**AMENDMENT 6: Maintenance #13:
Power over ethernet over 2 pairs**

Reference number
ISO/IEC/IEEE 8802-3:2021/Amd.6:2021(E)

IEEE Std 802.3cq™-2020

Amendment 6: Maintenance #13: Power over Ethernet over 2 pairs

Figure 33–16—PD state diagram

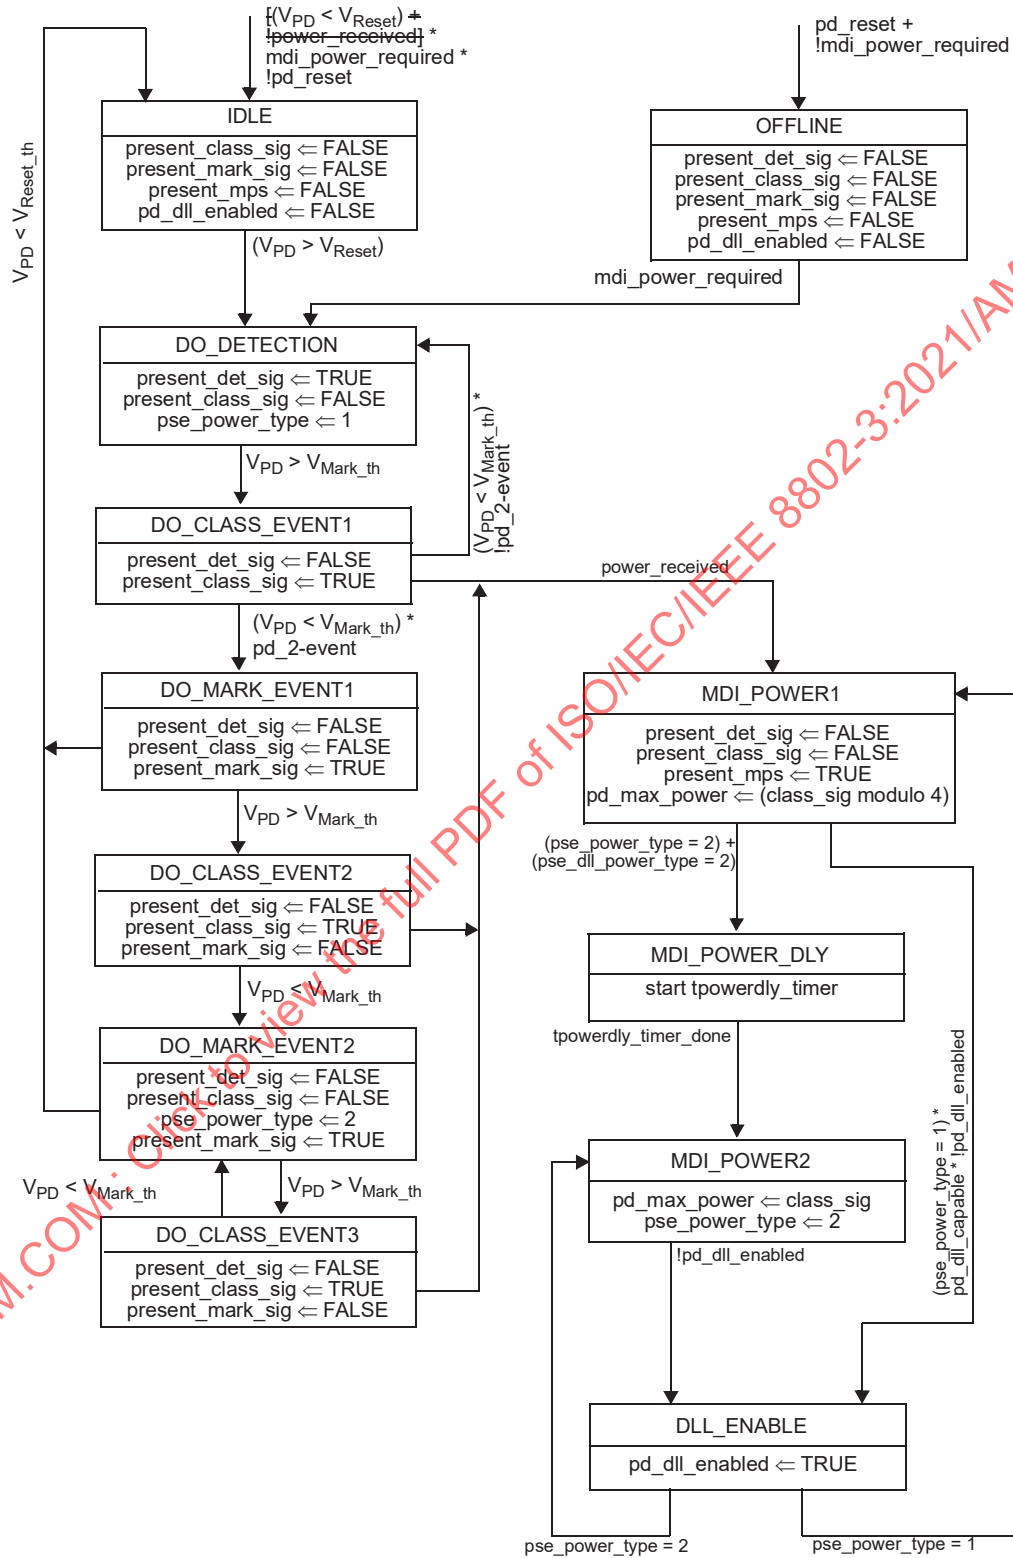
Change Figure 33–16 as follows:
